EXTRACT FROM COUNCIL MEETING MINUTES OF JUNE 4. 2013

1 MAPLE GO STATION SECONDARY PLAN FILE 26.8

RELATED FILE: OFFICIAL PLAN AMENDMENT APPLICATION OP.12.018
YORK MAJOR HOLDINGS INC.
WARD 4

FILE 26.8
RELATED FILE: OFFICIAL PLAN AMENDMENT APPLICATION OP.12.018
YORK MAJOR HOLDINGS INC.
WARD 4

Conceptual Site Plan

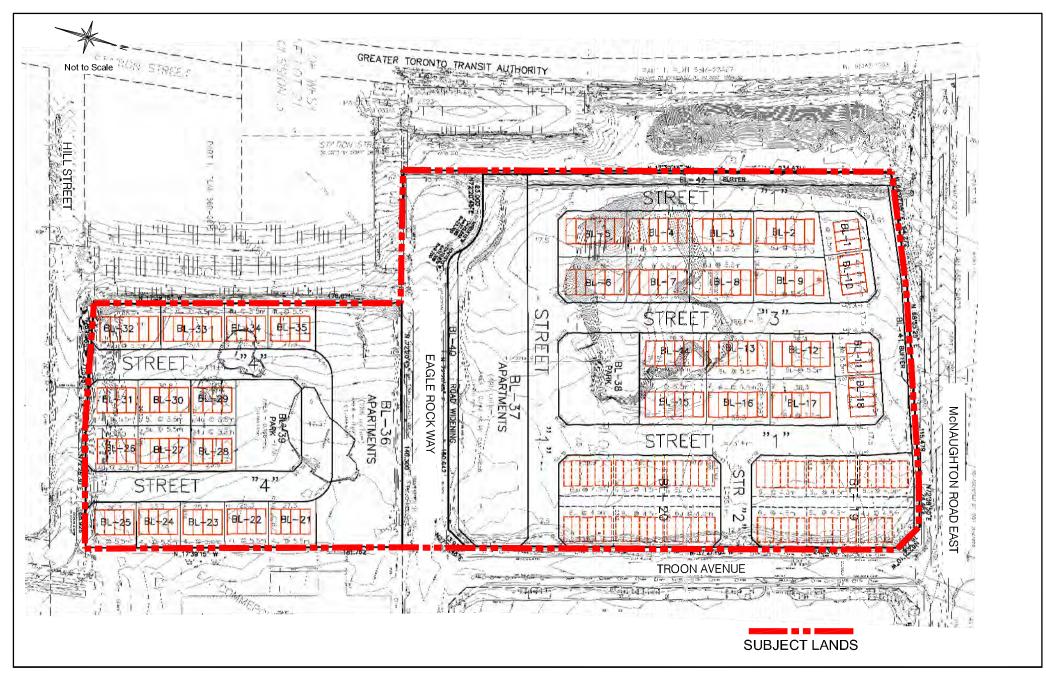
- a. The proposed plan lacks a north/south road connection across Eagle Rock Way.
- b. The termination of Eagle Rock Way in a cul-de-sac which provides access to the GO Station parking lot is a barrier to improved access and connections for the community. The cul-de-sac will define Eagle Rock Way as "the transit access street" and create undue conflicts between transit vehicles; passenger drop-off; other vehicles and pedestrians.
- c. The plan lacks of an east-west connection from Hill Street east of McNaughton Road across the proposed retail lands.

The site's surrounding streets and uses require attention in the planning of this area. The proposed design responds to the existing context rather than to the potential future development of the surroundings, and as such, is internally oriented. In terms of integration and connectivity with the surrounding areas, the proposed plan could be improved if the potential for the area's future was taken into consideration.

An improvement could be made by moving the mid-rise buildings closer to the Troon Avenue frontage and introducing mixed-use mid-rise buildings along the street. This site layout could create a better relation to the neighbouring commercial site and expand the site plan concept into a two-spine layout. This site orientation would also resolve the flankage condition and could create a stronger north-south pedestrian connection to Major Mackenzie Drive.

The DRP thought that greater mix of heights could provide better transitioning opportunities between the proposed 12-storey mid-rise and 2-storey townhouse building types. This may also bring an opportunity to resolve shadowing impacts on Eagle Rock Way.

DRP expressed a concern with respect to the substantial amount of retail proposed along Eagle Rock Way and its viability if the main street is active only during transit pick up and drop off hours. The introduction of office use would increase the amount of pedestrian traffic during the day to provide more support for the proposed retail.

The proposed internal parks do not have active edges, but rather face either the rear side of the mid-rise buildings or townhouse flankages. Buildings should address the parks. Furthermore, the DRP questioned whether the parks were large enough to appropriately meet the needs of the future community and to create an animated public space. The quality and size of the proposed parks should be increased to appropriately serve this emerging community.

- 3. There is an opportunity to provide a high-quality, comfortable and safe pedestrian access along Troon Avenue by extending the sidewalk, connecting McNaughton Road to Hill Street and to improve and enhance pedestrian connectivity through and beyond the site;

- 6. The existing topographic conditions of the site on the west, where the land significantly slopes down, would potentially create an unpleasant urban environment by exposing the proposed underground parking garage walls to the surrounding public realm. The proposed design should include smaller scale and three dimensional drawings to study and respond better to the site conditions at the zoning or site plan stage of review.

Subsequently, the Applicant revised the 2 rows of townhouses on the east side of the North Block by providing townhouse units accessed by a private rear lane as shown on Attachment #3. Also, improvements to connections to and from the site are being examined through the Major Mackenzie streetscape project and review of nearby development applications. In addition, discussions are underway with Metrolinx on how to achieve improved access and connections for the community as part of future station upgrades. At this point in time the revision to the street towns on the block constitutes the only significant change made by the applicant in response to the peer review comments listed above. The peer review comments have assisted in identifying issues to be addressed in the submission. The revised plan was provided as part of the submission to the Development Planning Department and was circulated accordingly for comments and presented to the Design Review Panel.
